**PLANNED UNIT DEVELOPMENT,  
SUBDIVISION & SIDEWALK WAIVER  
STAFF REPORT**

**Date: August 17, 2017**

<b><u>DEVELOPMENT NAME</u></b>	Shree Mahesh Subdivision
<b><u>SUBDIVISION NAME</u></b>	Shree Mahesh Subdivision
<b><u>LOCATION</u></b>	3650 Airport Boulevard and 600 West I-65 Service Road South (West side of West I-65 Service Road South, 250' ± North of Airport Boulevard Service Road.
<b><u>CITY COUNCIL DISTRICT</u></b>	District 5
<b><u>AREA OF PROPERTY</u></b>	2 Lots / 1.3 ± acres (Subdivision) 1 Lot / 9.39 ± acres (Planned Unit Development)
<b><u>CONTEMPLATED USE</u></b>	Planned Unit Development Approval to allow multiple buildings on a single building site, Subdivision Approval to create 2 legal lots, and a Sidewalk Waiver request to waive construction of a sidewalk along West I-65 Service Road South.
<b><u>TIME SCHEDULE FOR DEVELOPMENT</u></b>	None given.
<b><u>ENGINEERING COMMENTS</u></b>

# DETAIL SITE PLAN

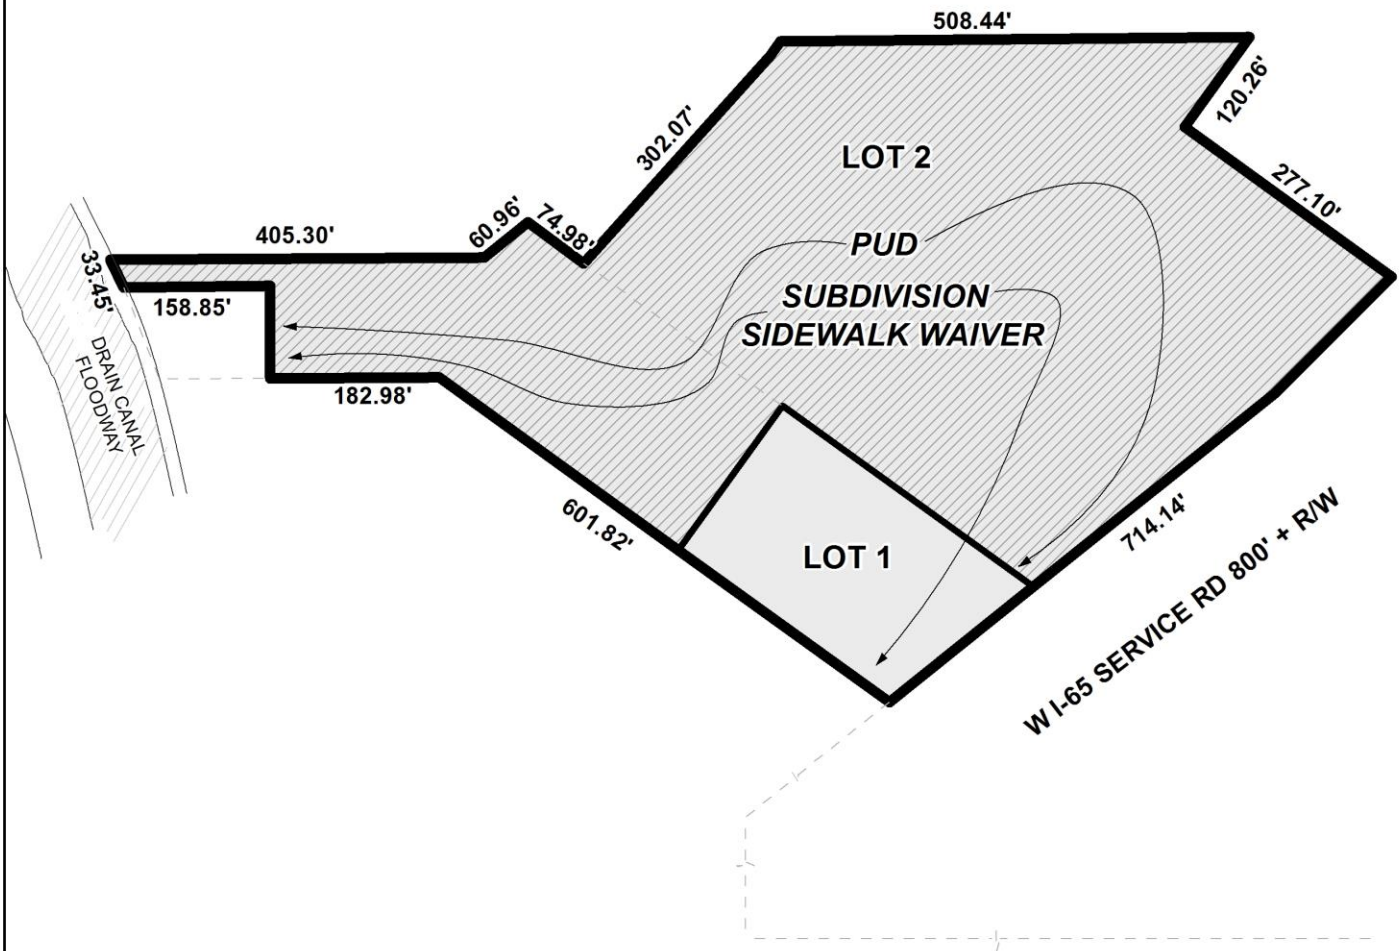
The proposed lots, as depicted, meet the minimum size and frontage requirements of the Subdivision Regulations. The lot area sizes are depicted on the plat in square feet and acres. The lot sizes should be retained in square feet and acres on the Final Plat, if approved. The PUD site plan does not depict the lot sizes in square feet and acres; thus a revision of the site plan to reflect this information is required.

The 25-foot minimum building setback line is not depicted on the preliminary plat or on the site plan. Both the plat and the site plan should be revised to depict the 25' minimum building setback line.

The site fronts the West I-65 Service Road South, part of the I-65 and Airport Boulevard interchange road network. Sufficient right-of-way exists for the service road, thus no dedication is required. The right-of-way is not identified on the site plan and is labeled as 880' + on the preliminary plat.

A dumpster is depicted on the site plan with a note stating the dumpster pad will be connected to sanitary sewer and enclosed. A site plan illustrating compliance with Section 64-4.D.9 of the Zoning Ordinance regarding new dumpsters will be required on any future site plans.

- 1) revision of the site plan to depict the lot sizes in square feet and acres;
- 2) revision of the site plan to depict the 25' minimum building setback lines along where the property lines abut road frontage;

- 3) retention of the right-of-way widths on the site plan;
- 4) placement of a note on the site plan stating that the lot is limited to the existing curb-cuts, with the size, design and location to be approved by Traffic Engineering and ALDOT (as appropriate) and comply with AASHTO;

- 5) revision of the site plan to reflect frontage tree planting compliance and overall landscaping calculations;
- 6) compliance with Engineering comments: *“ADD THE FOLLOWING NOTES TO THE PUD SITE PLAN: 1. Any work performed in the existing ROW (right-of-way) such as driveways, sidewalks, utility connections, grading, drainage, irrigation, or landscaping will require a ROW permit from the ALDOT and from the City of Mobile Engineering Department (208-6070). All sidewalk work must comply with the City of Mobile Right-of-Way Construction and Administration Ordinance (Mobile City Code, Chapter 57, Article VIII). 2. A Land Disturbance Permit application shall be submitted for any proposed land disturbing activity with the property. A complete set of construction plans including, but not limited to, drainage, utilities, grading, storm water detention systems, paving, and all above ground structures, will need to be included with the Land Disturbance permit. This Permit must be submitted, approved, and issued prior to beginning any of the construction work. 3. Any and all proposed land disturbing activity within the property will need to be submitted for review and be in conformance with Mobile City Code, Chapter 17, Storm Water Management and Flood Control); the City of Mobile, Alabama Flood Plain Management Plan (1984); and, the Rules For Erosion and Sedimentation Control and Storm Water Runoff Control. 4. The approval of all applicable federal, state, and local agencies (including all storm water runoff, wetland and floodplain requirements) will be required prior to the issuance of a Land Disturbance permit. The Owner/Developer is responsible for acquiring all of the necessary permits and approvals. 5. The proposed development must comply with all Engineering Department design requirements and Policy Letters.”;*
